EWER	GENCY DRU	UGHT APPI	LICATION: 0	GROUNDWAIER R	EVIEW	
TO:	Water Right	ts Section				Date: _	05/05/2021
FROM:	: Groundwate	er Section:		I Thoma er's Name			
SUBJE	CT: Application	G- <u>19109</u>		□R	e-review; date of origi	nal review: _	##/##/###
evaluate ground Departr within t	e an emergency reque water availability, sta ment may issue a dro the public interest as	est for groundw bility of the grought permit for per OAR 690-0	ater use for on oundwater resor short-term e 019-0040(3).	e season under ource, and sur emergency use	t Mitigation rules. To r a Governor's drought face water and Scenic provided that there is	declaration. Waterway co no injury ar	Notwithstanding onsiderations, the nd that the use is
	nent of temporary em nes for 2021 Emergeno				in part, on the attached April 12, 2021.	ed memorano	dum: " <u>Processing</u>

A. <u>GEN</u>	NERAL INFORMA	TION:					
Applica	ant's Name:	Wright Family	Farm			County:	Klamath
A1.	Applicant(s) seek(s)	0.49	cfs from 2	well(s) in	the Klamath Tule Lake		
A2.	Proposed use:Irr	igation: 39.0 a	cres		Seasonality:	2021 Irri	gation Season
A3.	Well and aquifer dat	a (attach and	number logs	for existing w	ells; mark proposed	wells as such	n

**Application Review Map**

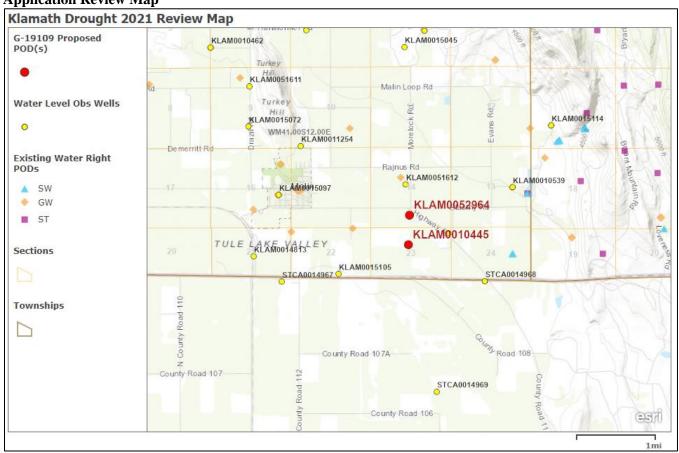
B3. G	Groundwater ( $\square$ is) ( $\boxtimes$ is not) available within the capacity of the resource, Comments:
0	Groundwater levels have declined noticeably across almost the entire Lost River Subbasin within the past 20 years and ver 20 feet in some areas implying that the groundwater resource is over-appropriated as defined in OAR 690-400-010. Increased use by drought-permit wells and supplemental groundwater rights are anticipated to continue these eclines.
	There $(\boxtimes is)$ $(\square is not)$ a preponderance of evidence that the proposed short-term emergency groundwater use will neasurably reduce the surface water flows necessary to maintain the free-flowing character of a scenic waterway.
<u>U</u> <u>W</u> <u>sı</u>	a preponderance of evidence exists to establish that groundwater development occurring in Oregon since 1995 in the Upper Klamath Basin and Lost River subbasin has "measurably reduced" surface water flows within the Klamath Scenic Vaterway (refer to attached memo dated 2/19/2013). Short term emergency groundwater uses will further reduce urface water flows in the Klamath Scenic Waterway. The timing and degree (amount of reduction in flow) of additional mpacts from the proposed short-term emergency groundwater use is beyond the scope of this review.
